SUNDRY NOTICES AND REPORTS ON WELLS
Do not use this form for proposals to drill or to re-enter an abandoned well. Use Form 3160-3 (APD) for such proposals.

Quick Draw 14 F Fed #1

30-015-37366

**Quick Draw 14 F Fed #1
30-015-37366
Mewbourne Oil Company
May 19, 2010
Conditions of Approval**

Well Name: Quick Draw "14" F #1
Proposed Wellbore

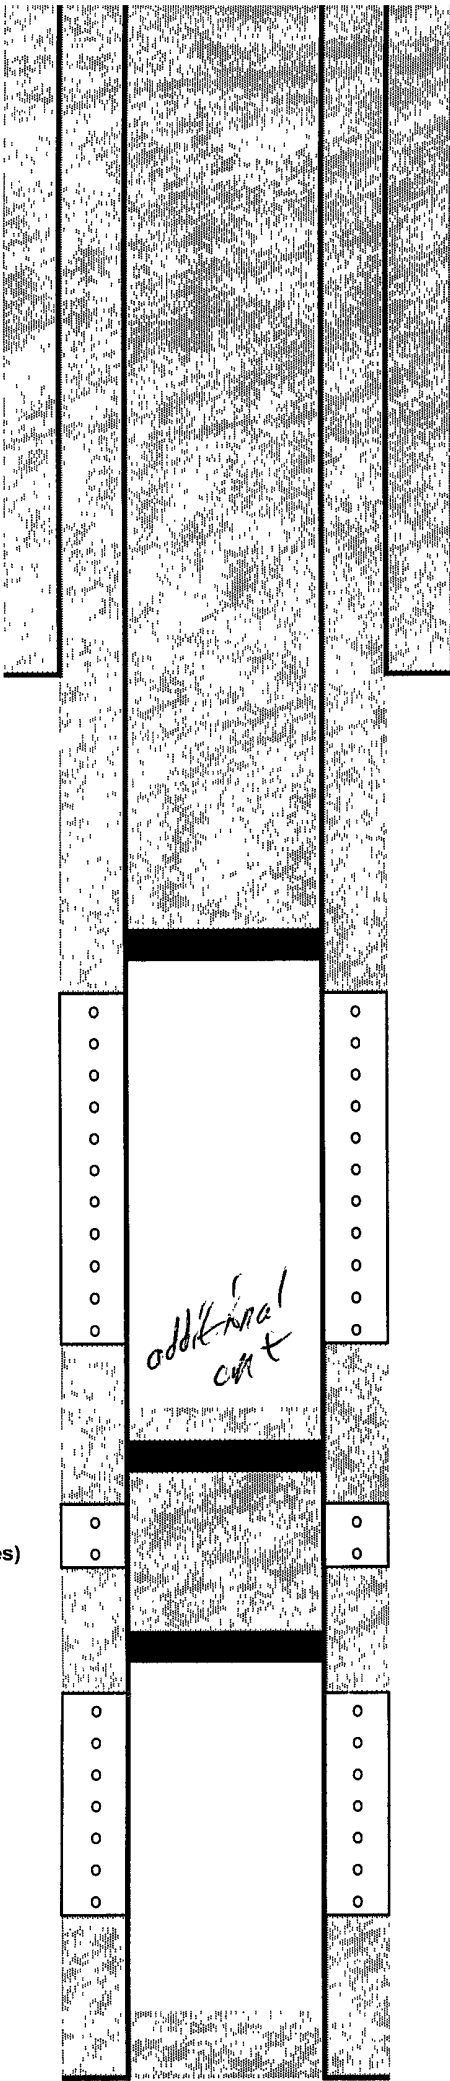
- 1. Operator to tag cement on retainer at 2404' and then pump a 25 sack Class C plug at that depth.**
- 2. CIBP cannot be tested to 3000 psi as that will exceed 70% of the burst at 1035'.
Maximum surface pressure shall not exceed 2500 psi.**
- 3. See attached COA for plugging and reclamation.**
